Municipal Utilities Building Renovation – Madison, SD

Addendum Issue Date: November 01, 2018

MEP Addendum #2

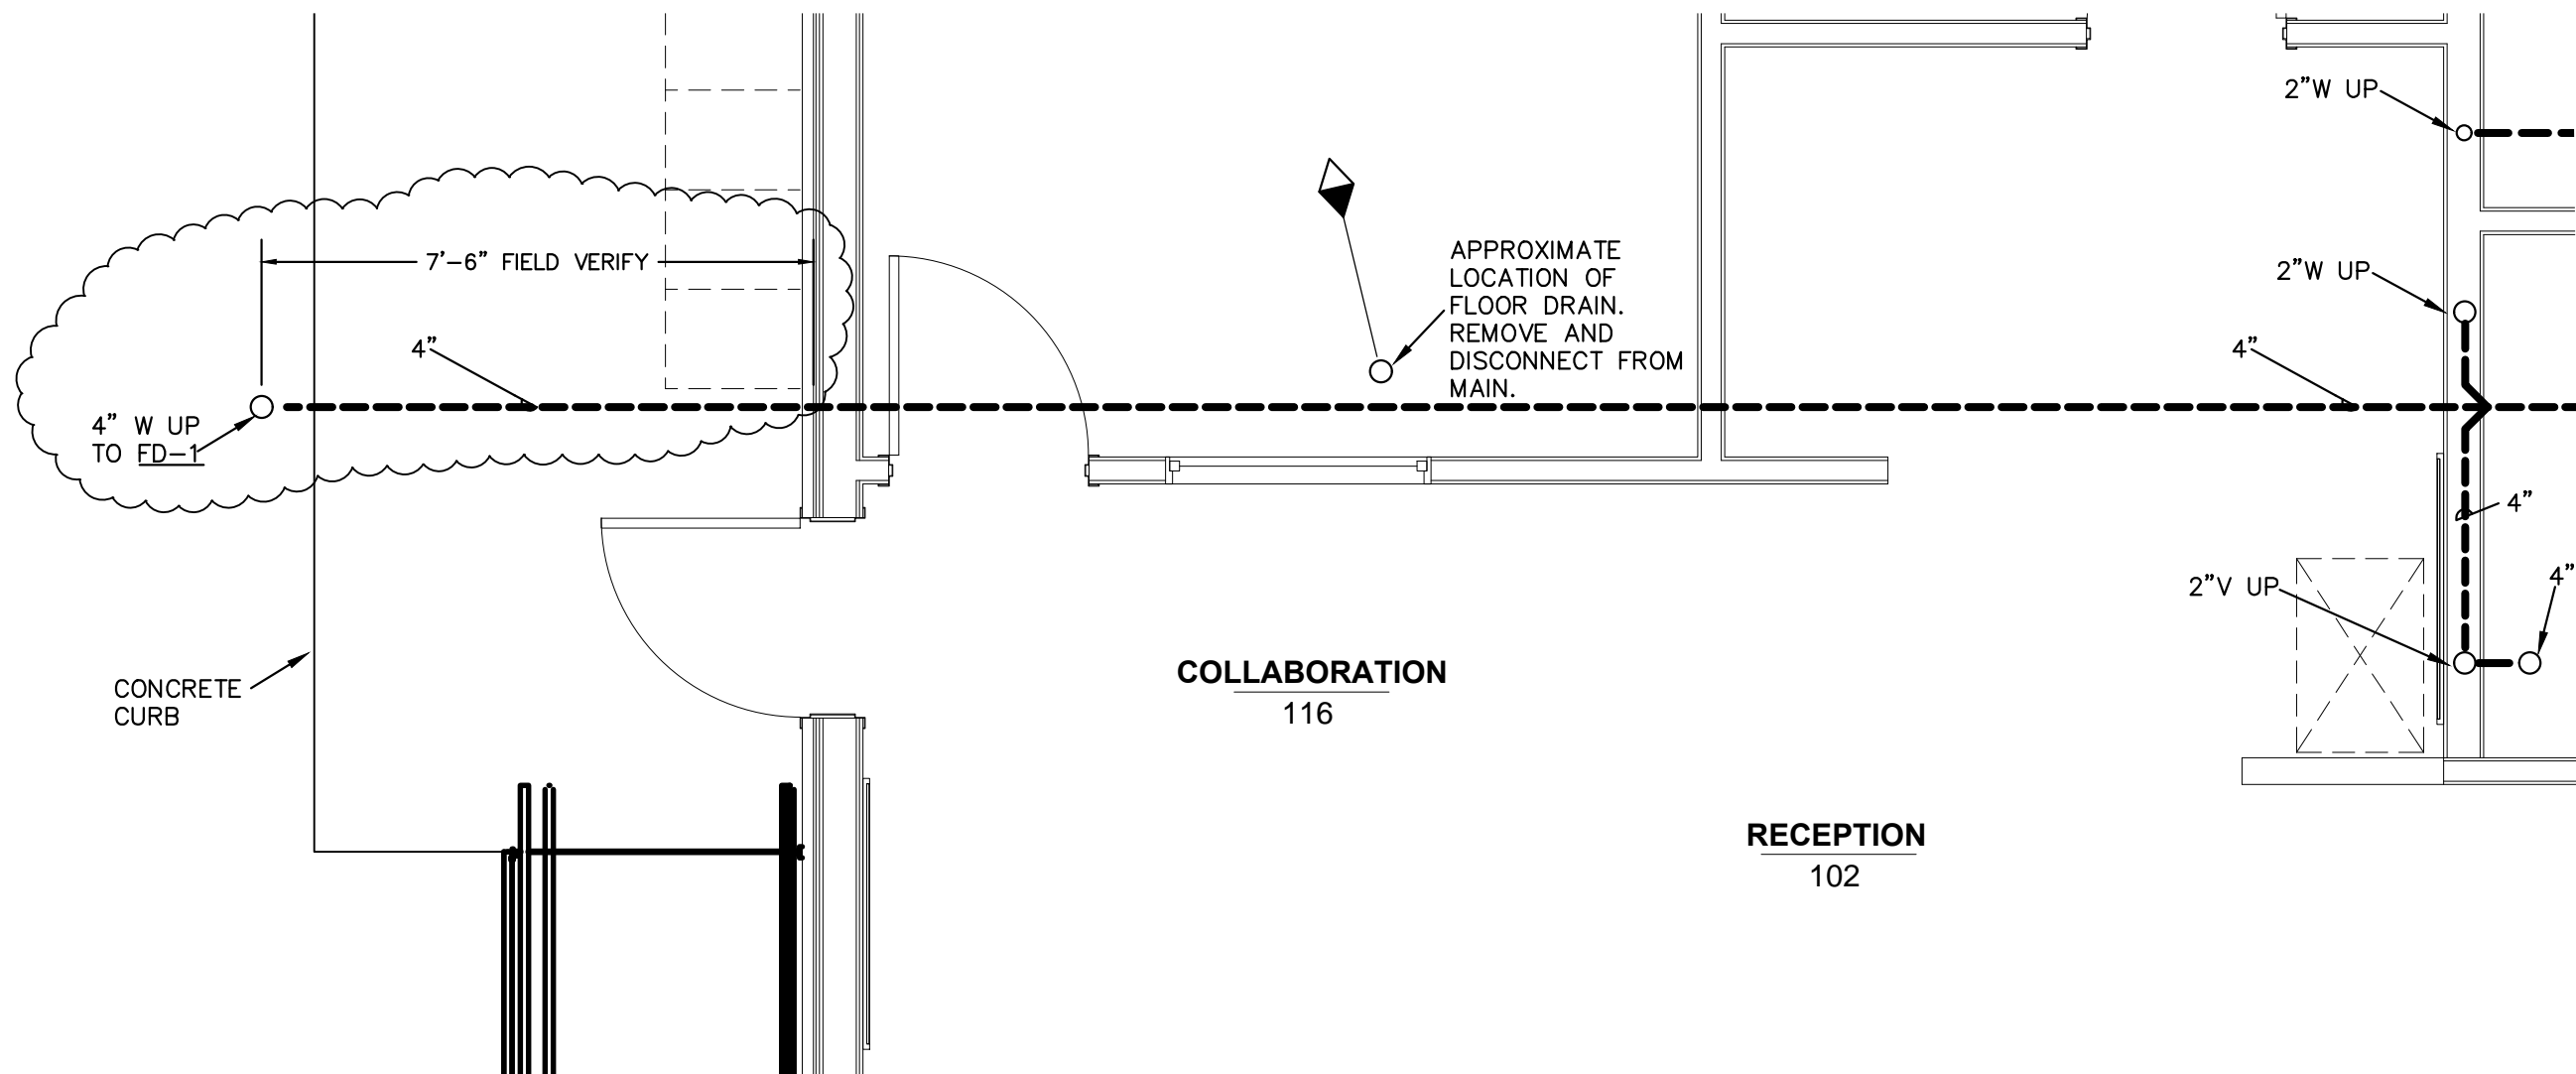
Sheet M1.1

- 1) Install new floor drain just past the edge of curb, approx.. 7'-6' from face of finished wall.
Contractor to field verify exact location. See sketch M1.1 SK-2 for details.
